Westinghouse
Electric Corporation

Subject: Justification of Reduced Flow Meter Measurement Uncertainties
Reference: Texas Utilities Generating Company Letter, Council to Denton,
September - 1985

Questions:

FIGURE 1
POWER CALORIMETRIC SCHEMATIC

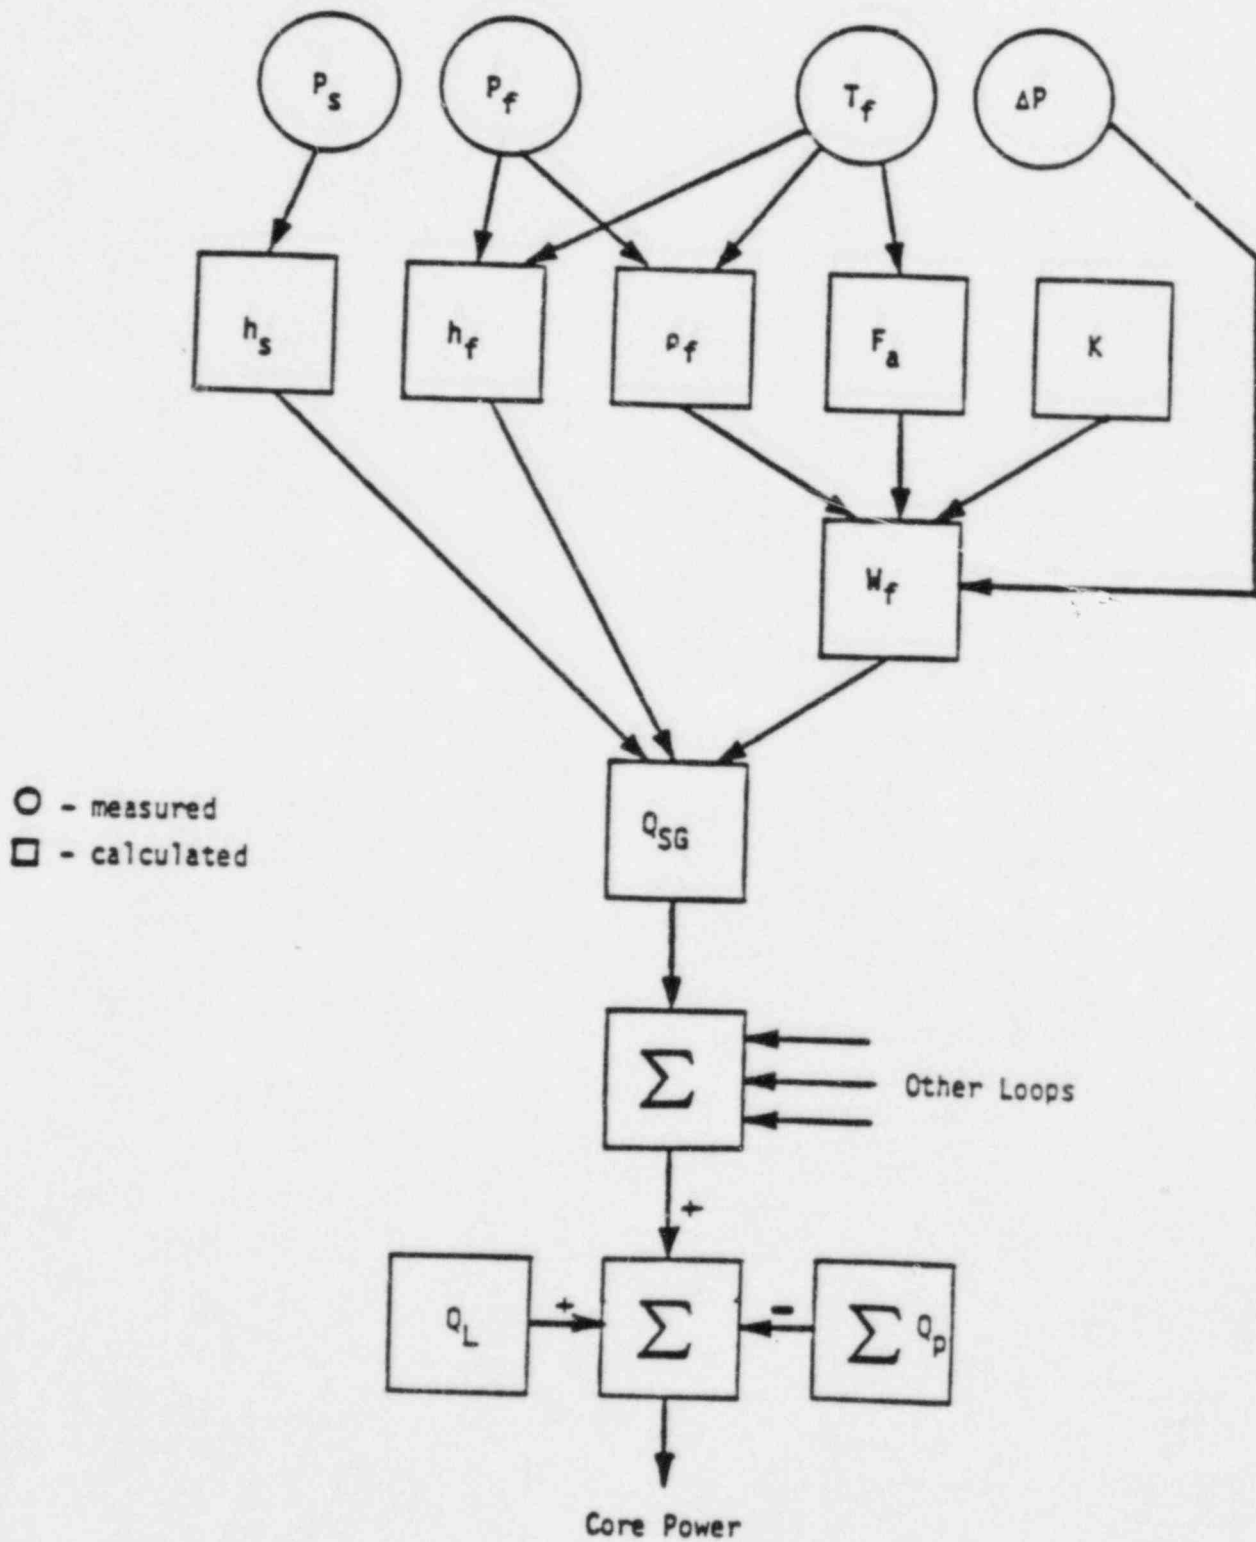
1. Provide and justify the variances and distributions for input parameters.
2. Justify that the nominal conditions used in the analyses bound all permitted modes of plant operation.
3. Provide a block diagram depicting sensor, processing equipment, computer, and readout devices for each parameter channel used in the uncertainty analysis. Within each element of the block diagram identify the accuracy, drift, range, span, operating limits, and setpoints. Identify the overall accuracy of each channel transmitter to final output and specify the minimum acceptable accuracy for use with the new procedure. Also identify the overall accuracy of the final output value and maximum accuracy requirements for each input channel for this final output device.

The core power measurement is based on the following plant measurements:

These measurements and calculations are presented schematically on Figure 1.
